To ABB Master Technical Information Binders	Dept. ATCF/CS/SV	Date 2002-11-18	Reg.nr	Page 1(2)
	Dealt with by, telephone Support Center Västerås			Cont.

HARDWARE ERROR
 Advant Controller 450
 Older Product Revisions of PM511 can cause slow performance on MB300 or MVI

Figure 1 Location of Product Revision label on PM511V08 or PM511V16

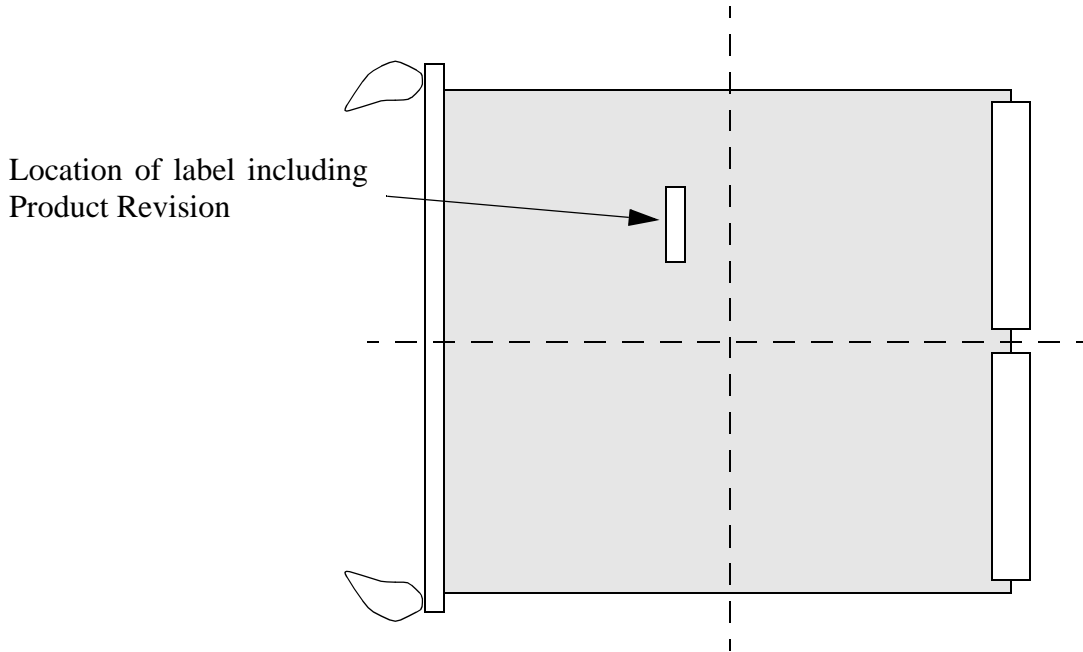
It has been detected that PM511V08 or PM511V16 with Product Revision A or B in very rare situations can cause MasterBus 300 or MVI traffic to slow down. This problem can occur for a CS513 (Masterbus 300), CI532Vxx, CI534Vxx or CI535Vxx (MVI) submodules. This is due to that HW interrupts may fail in very rare situations on early PM511Vnn Product Revisions (A or B). These Product Revisions of the PM511Vnn CPU were produced from end of 1997 until August 1998.

The problem is corrected on PM511 PR:C and later Product Revisions.

Figure 1 below indicates where the Product Revision label is located on PM511V08 or PM511V16.

Return the PM511V08 or PM511V16 with Product Revision A or B, using the RMA (Return Material Authorization) handling and specify that the module needs to be upgraded to Product Revision C or higher.
